Historical Areas Board of Review(HABR)

Project Name: B. Meyer 23 Closter Rd, Palisades #1

Changes were made to the original plans based on the following:

Approved on original plan and what was used instead.

2 WEST ELEVATION - PROPOSED
SCALE: 1/4" = 1'-0"

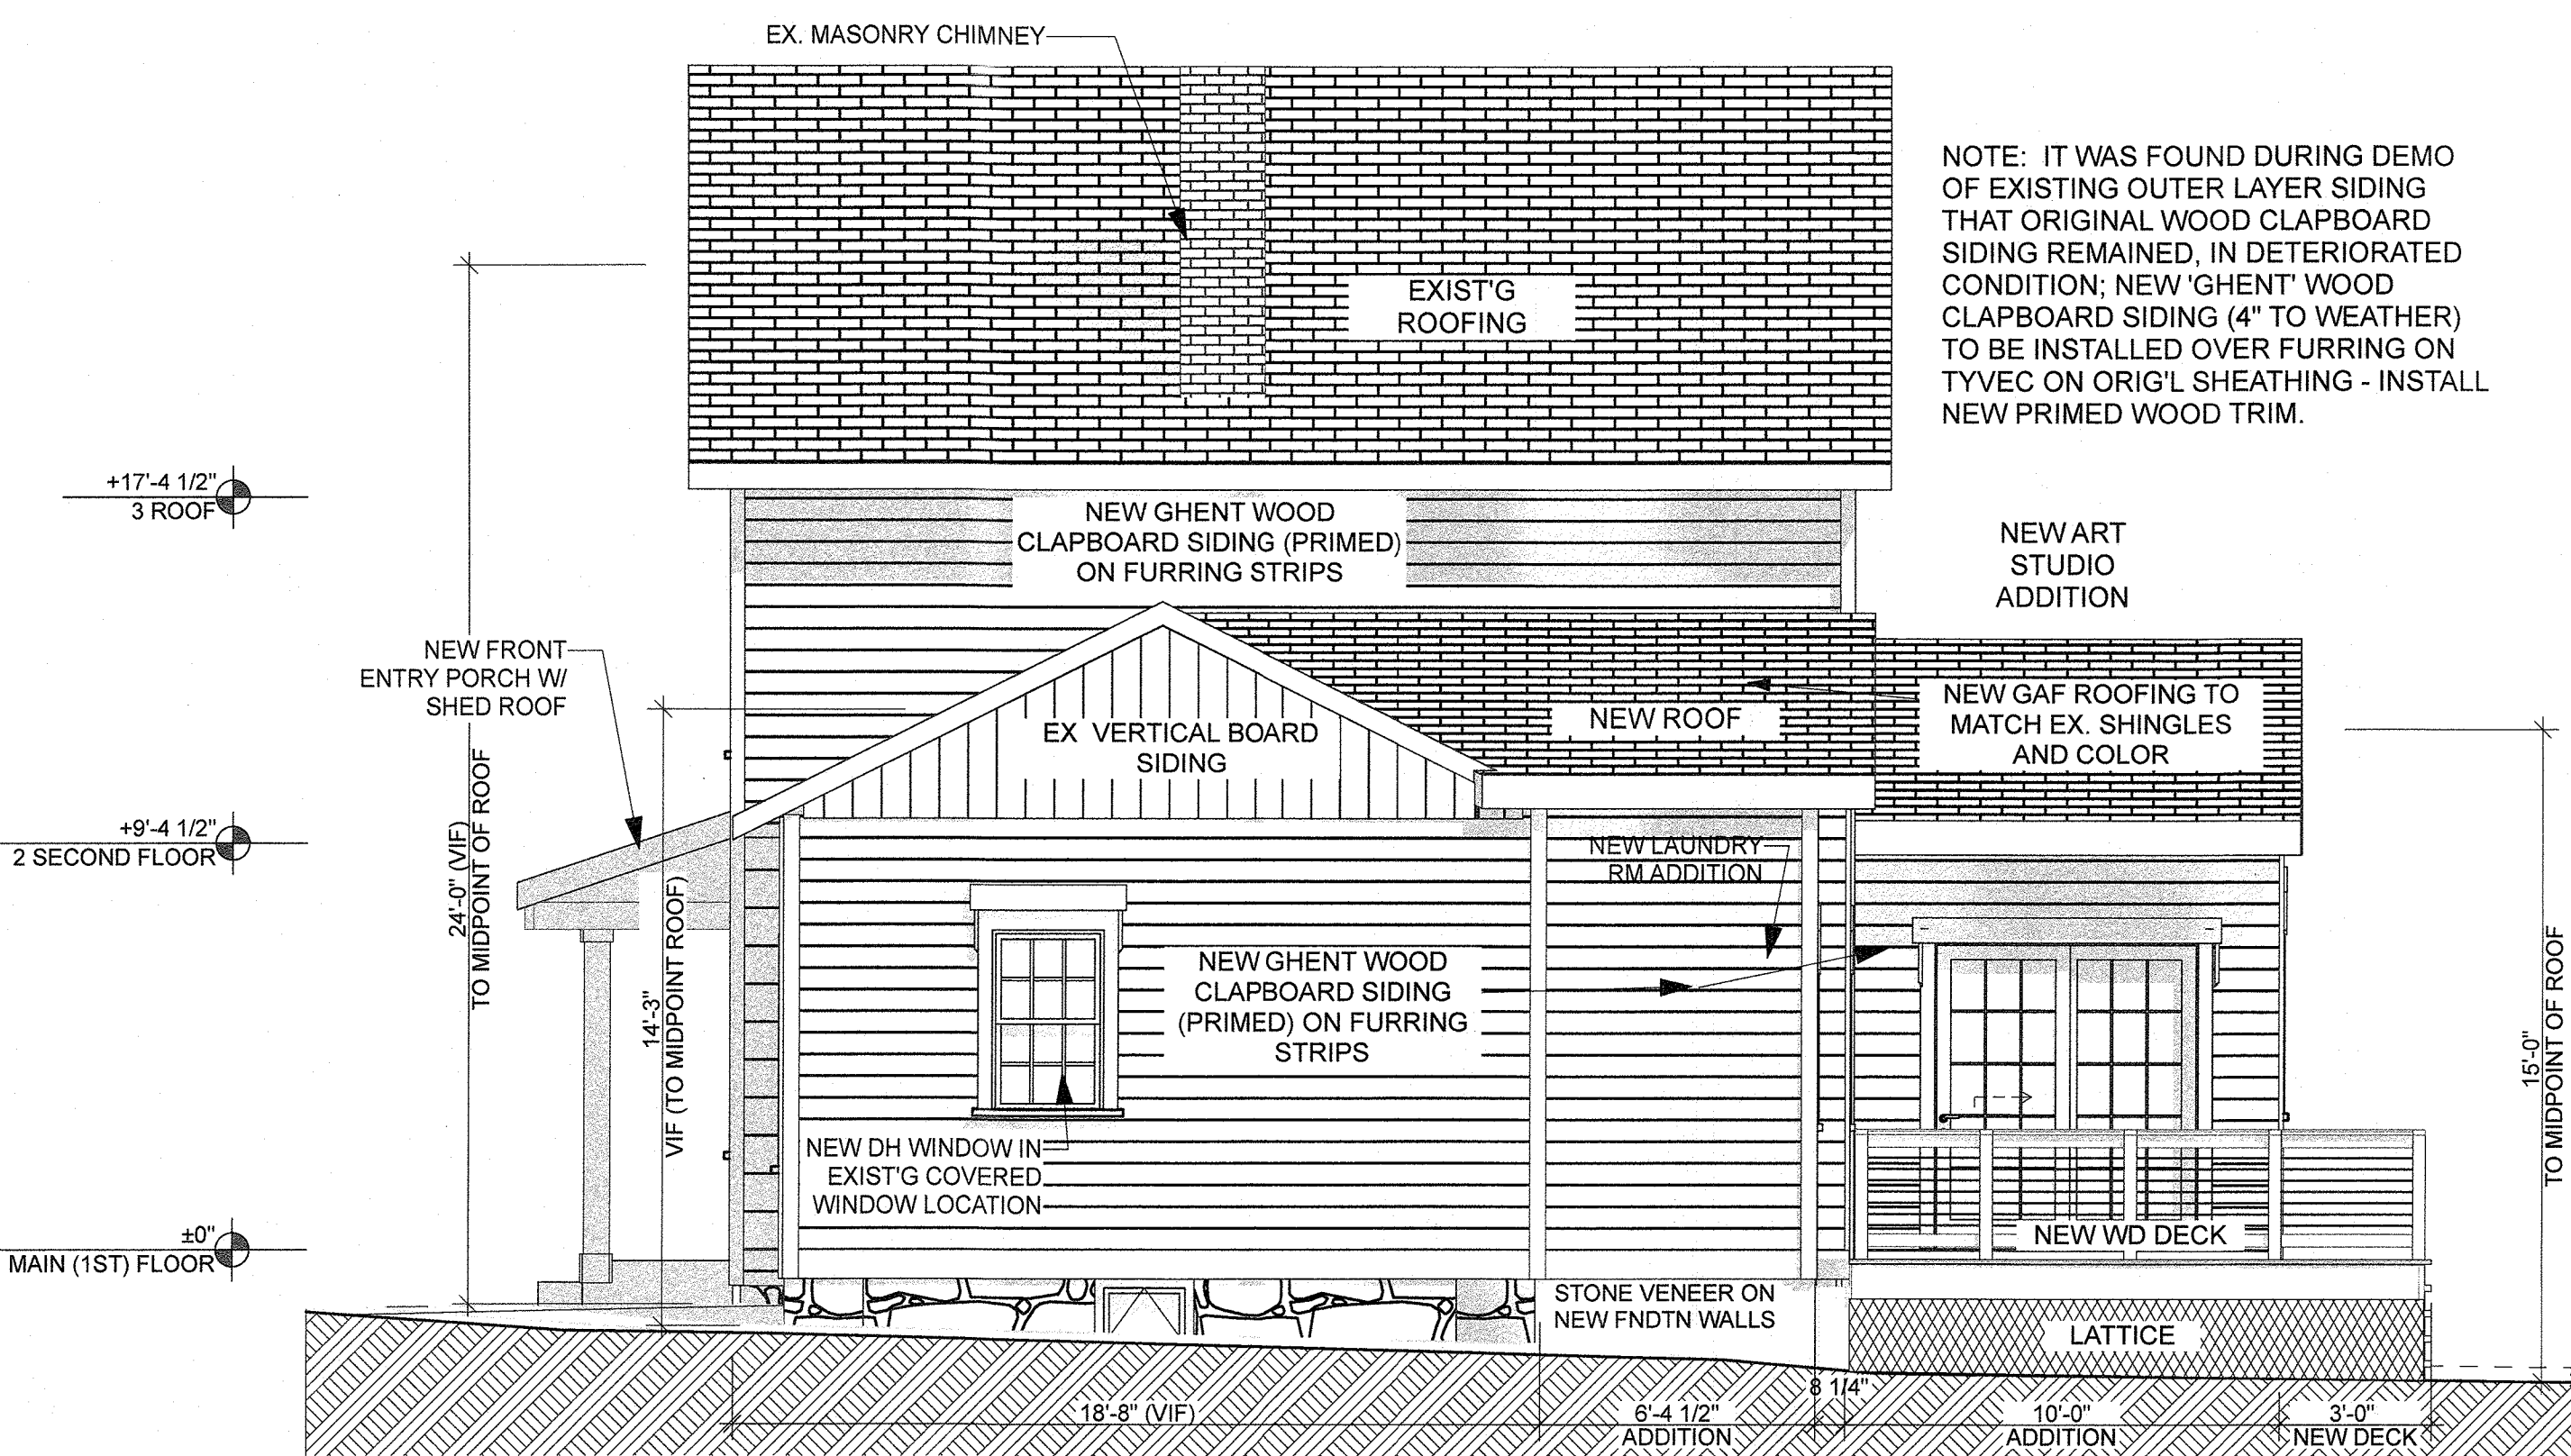
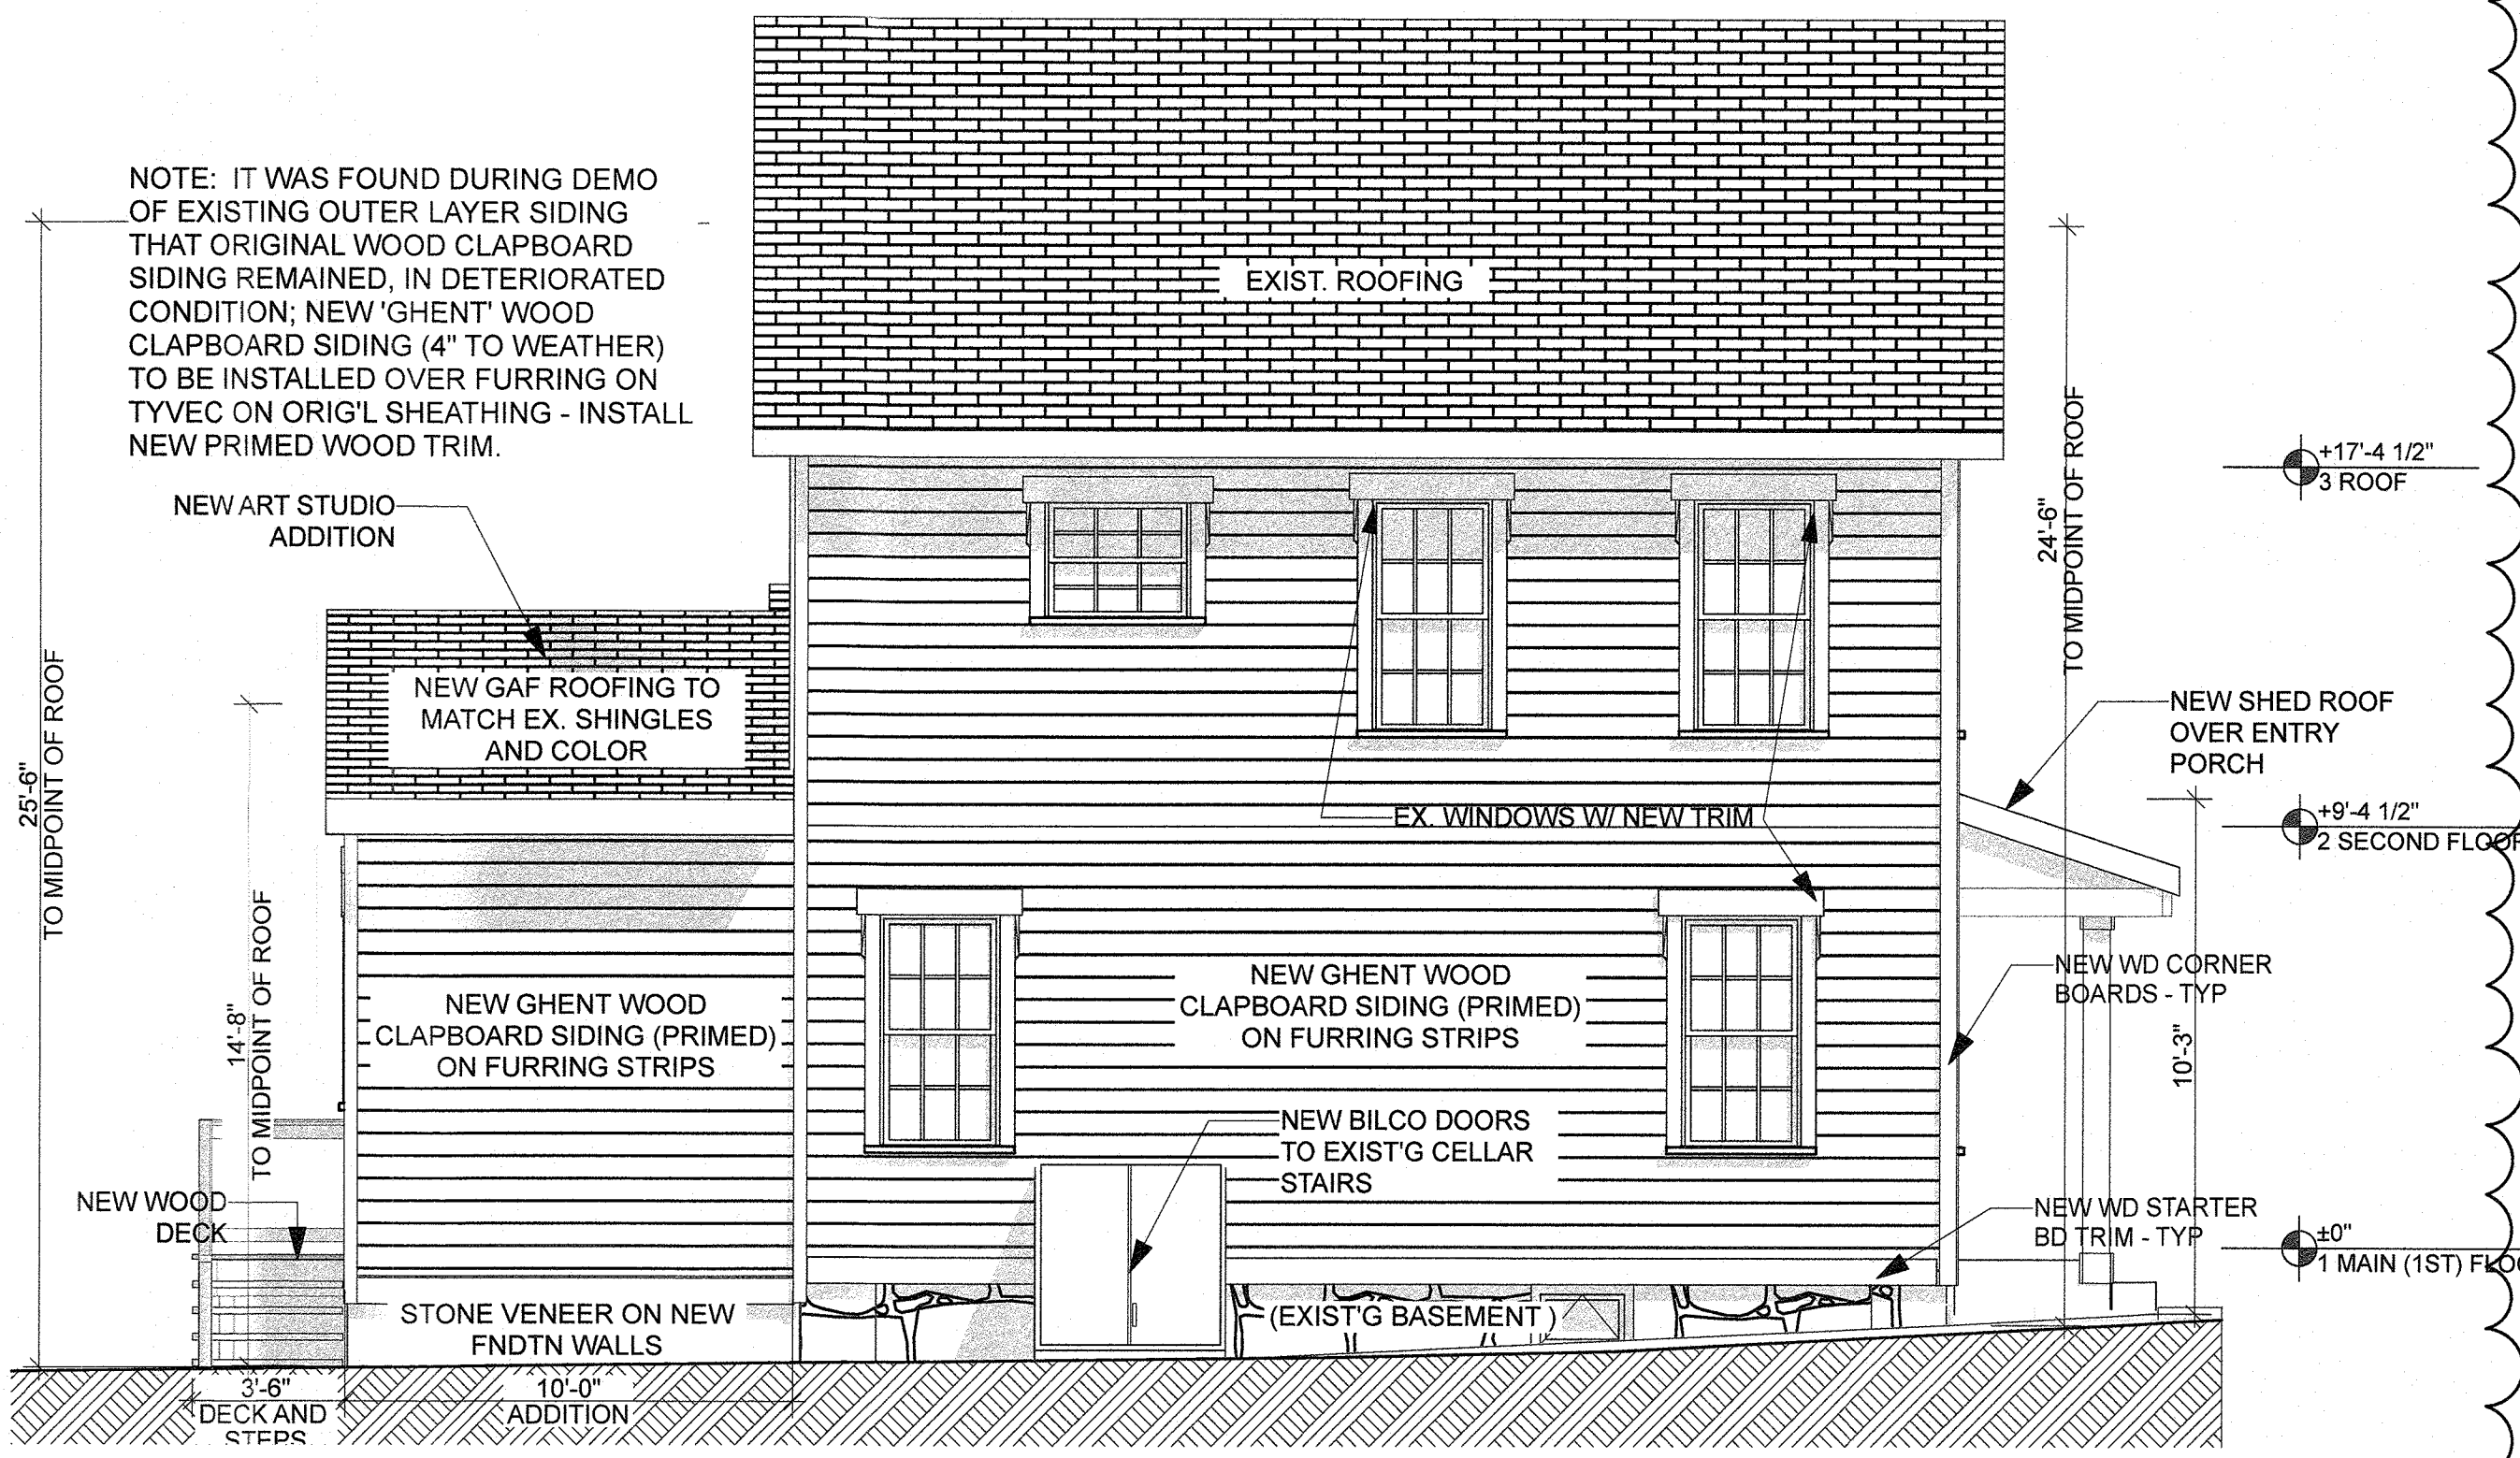
MATERIALS AND FINISH SCHEDULE			
ITEM	COLOR	MATERIAL	MANUFACTURER
ROOF	CHARCOAL	FIBERGLASS SHINGLES	GAF TIMBERLINE 'NS' - MATCH EXIST
SIDING	WHITE	GHENT WOOD CLAPBOARD SIDING W/ 4" TO WEATHER	GHENT LUMBER-
SOFFITS, FASCIA, GUTTERS	WHITE	PRIMED WD SOFFIT+FASCIA ALUMINUM GUTTERS	PLYGEM OR ROLLEX (GUTTERS)
WINDOWS, SLIDING DRS	WHITE	VINYL CLAD	MI 1600 SERIES; DOUBLE HUNG & SLIDING DRS
TRIM	HISTORIC SAGE	PRIMED WOOD TRIM BOARD	GHENT LUMBER
STONE OR ROCK	MATCH EX. STONE	CULTURED STONE	TO MATCH EXISTING FOUNDATION
REAR DECK & RAILING	PT WOOD - 'GOLDEN PECAN' STAIN	PT WOOD POST, RAILS AND DECK W/ STL STL CABLE RAIL	PT (PRESSURE TREATED) WOOD (BECKERLEE LUMBER)+ CELY ND STAINLESS STEEL T316 CABLES

REVEALED ORIGINAL 'LADDER' STYLE OVERHANGS (ALL) (EXPOSED 2X FRAMING)

NOTE: IT WAS FOUND DURING DEMO OF EXISTING OUTER LAYER SIDING THAT ORIGINAL WOOD CLAPBOARD SIDING REMAINED, IN DETERIORATED CONDITION; NEW 'GHENT' WOOD CLAPBOARD SIDING (4" TO WEATHER) TO BE INSTALLED OVER FURRING ON TYVEC ON ORIG'L SHEATHING - INSTALL NEW PRIMED WOOD TRIM.
